MINUTES OF THE
SANTA FE COUNTY
DEVELOPMENT REVIEW COMMITTEE

July 16, 2009

- 2. **CDRC CASE #S 08-5210 Sandstone Pines Estates Preliminary and Final Plat/Development Plan. Anasazi MV JV LLC, applicant, Melvin Varela, agent, request preliminary and final plat and development plan approval for a 12-lot residential subdivision on 42.99 acres. The property is located in Glorieta, North of I-25, South of State Road 50, within Sections 1 and 2, Township 15 North, Range 11 East (Commission District 4)**

Figure 3c. Kingsmill well number UP-2812 well log and lithologic explanation.

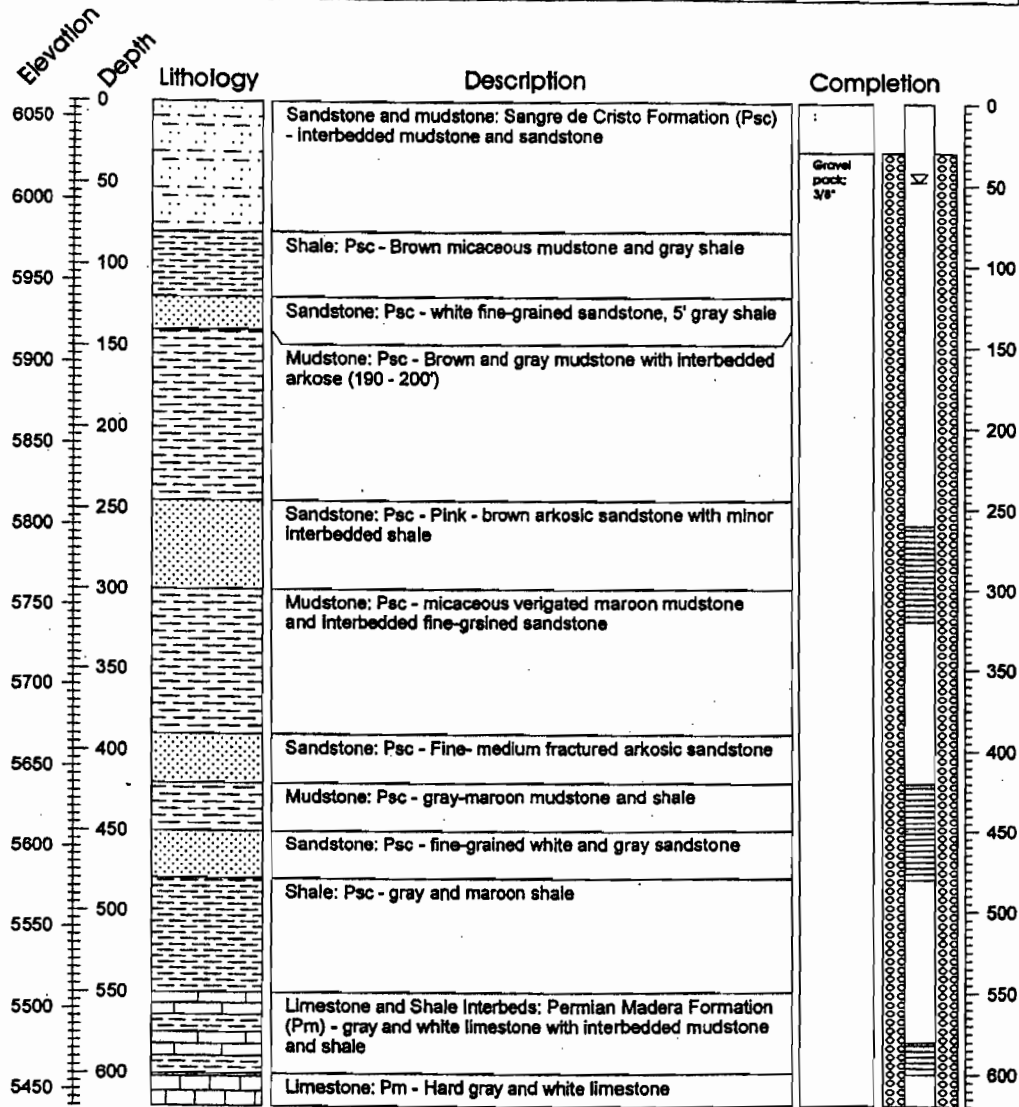
The saturated thickness in well UP-2812 is that material below 54 feet to the bottom of the well. Not all of the material encountered will provide water from storage to a well, however. The writer of this report was not on-site for the drilling of this well, but relied upon the driller's record and the well record prepared by GGI. The following table shows the material encountered by the well below 54 feet as described by the driller's log, and the specific yield value assigned to each particular sequence.
